SCHWEIZER SERVICE NOTICE

NOTICE NO. N-203

SUBJECT: VISUAL CHECK TO ENSURE THAT PROPER THRUST BEARING TUBE IS INSTALLED

MODELS AFFECTED: All 269 Series helicopters.

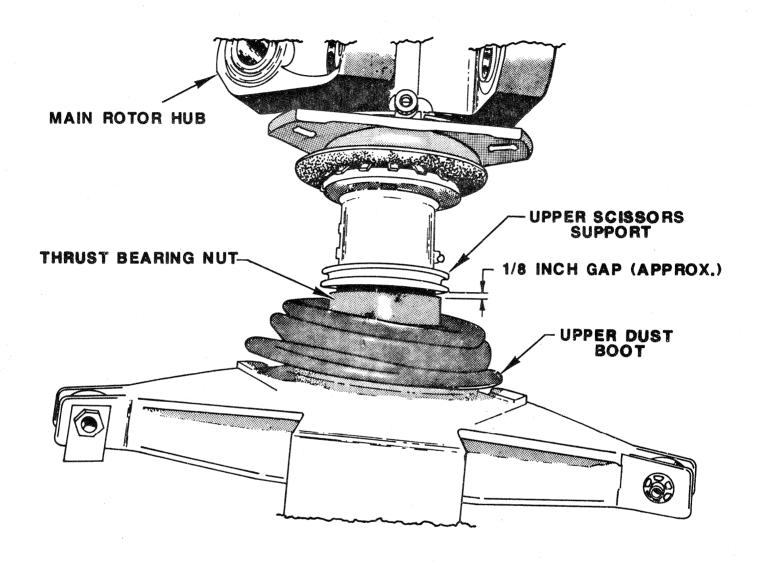
- a. Following installation of main rotor hub assembly (Basic HMI, Section 8), check for a gap between thrust bearing nut and scissors support as follows:
 - (1) Slide upper dust boot off from scissors support.
 - (2) Force boot downward to gain visual access.
 - (3) Determine that a gap (approximately 1/8 inch) exists between thrust bearing nut and scissors support. (See Figure 1.)

- b. If no gap exists, remove thrust bearing tube as follows:
 - (1) Remove main rotor hub and swashplate assembly (Basic HMI, Section 8).
 - (2) Bend eight tangs on thrust bearing nut lockwasher to clear thrust bearing nut and mast assembly.
 - (3) Remove thrust bearing nut using bearing nut wrench and a 30-inch extension arm.
 - (4) Remove thrust bearing tube.
 - (5) Check part number of thrust bearing tube against those listed in 269 Series IPC.
 - (6) Reinstall main rotor components using proper thrust bearing tube. (Refer to HMI Temporary Revision No. R-3.)
- c. Reinstall upper dust boot.
